Service Bulletin #264

SB-264
(01806)
ECN_8226

Ford F-250/F-350/F-450 (Single and Dual Rear Wheel) 57396 and 88396 Four-Wheel-Drive Underbracket Redesign

Which Design Do You Have?

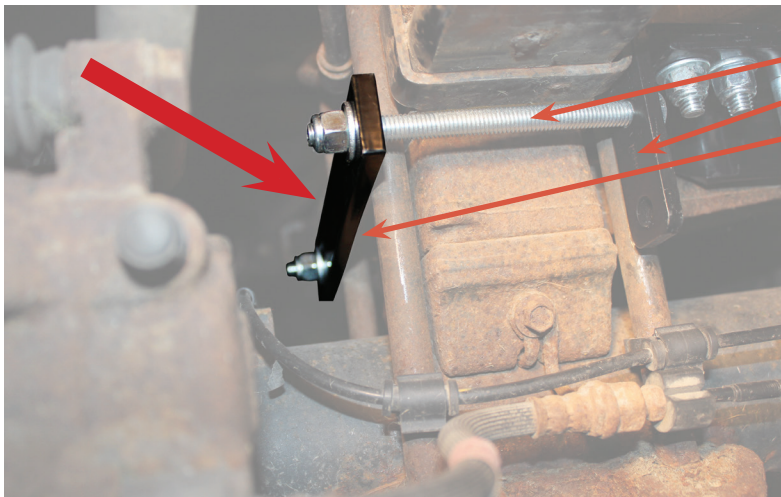
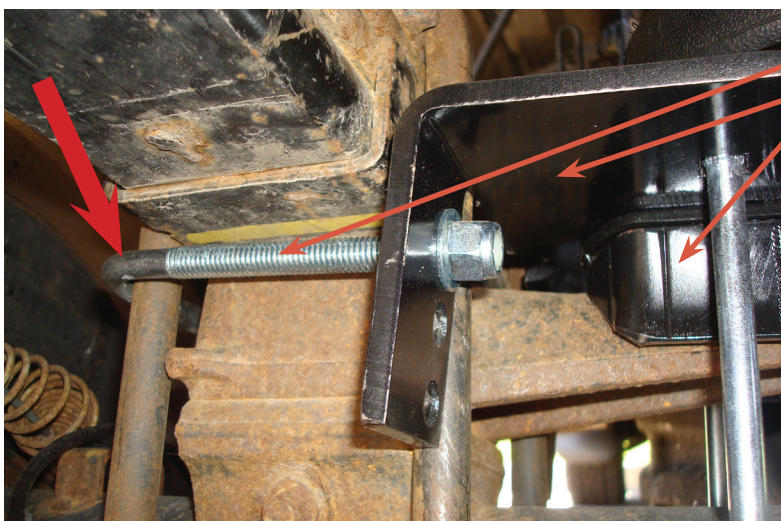
Background: The bottom bracket for this kit was redesigned to reduce complexity and installation time.

If the air spring's bottom plate is attached by two bolts holding a retainer plate alongside the vehicle's leaf spring mount, it is the 1st-generation design.

If the bottom plate is attached by a U-bolt, it is the second-generation design.
